Access Compliance Report

Public Rights-of-Way

Intersection ID: 12151	Main Street: W_MOREHEAD_ST	Cross Street: MILLERTON_AV	Location: NW
ADA ID: 8D88308552BB	Ramp Type: PerpDiag	Initial Pass/Fail: Fail	Overall Compliance: No
		Severity Score: 8.75

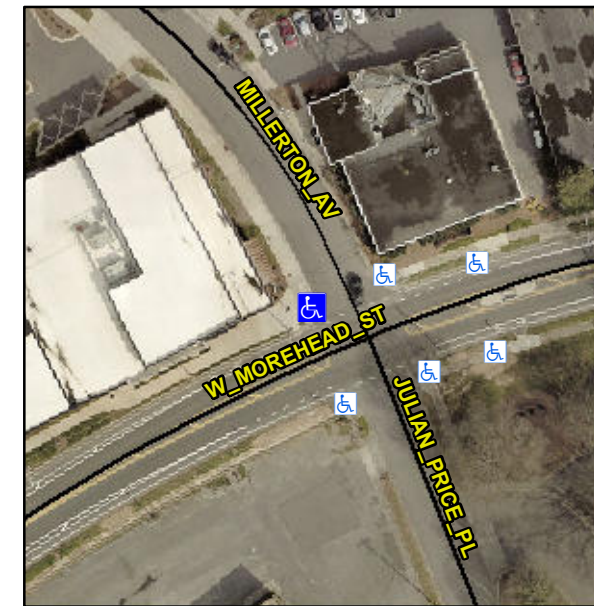
R304.5.1

Compliance	Description	Data	Compliance	Description	Data
N/A	Ramp Length (in)	50.0	Yes	Ramp Slope (%)	7.8
No	Ramp Width (in)	47.5	Yes	Ramp XSlope (%)	0.6
N/A	Flare Type LT	N/A	N/A	Flare Type RT	N/A
N/A	Flare Slope LT (%)	N/A	N/A	Flare Slope RT (%)	N/A
N/A	Flare Traversable LT?	N/A	N/A	Flare Traversable RT?	N/A
N/A	Landing Length (in)	N/A	N/A	DWS Provided?	N/A
N/A	Landing Width (in)	N/A	N/A	DWS Contrast?	N/A
N/A	Landing Slope (%)	N/A	N/A	DWS Length (in)	N/A
N/A	Landing X Slope (%)	N/A	N/A	DWS Full Width?	N/A
N/A	Landing Curb? (Y/N)	N/A	N/A	DWS Offset (in)	N/A
N/A	Shared Landing?	N/A			
N/A	Gutter Ponding?	N/A	N/A	Gutter Slope (%)	N/A
N/A	Gutter Lip Ht (in)	N/A	N/A	Gutter X Slope (%)	N/A
N/A	Painted X Walk1?	No	N/A	Painted X Walk2?	No
	X Walk 1 Direction	To S		X Walk 2 Direction	To E
N/A	X Walk 1 Width (in)	N/A	N/A	X Walk 2 Width (in)	N/A
	X Walk 1 Slope (%)	3.9		X Walk 2 Slope (%)	0.4
	X Walk 1 X Slope (%)	1.3		X Walk 2 X Slope (%)	0.3

Remove & Replace Curb Ramp With Two New Directional Ramps or Equivalent.
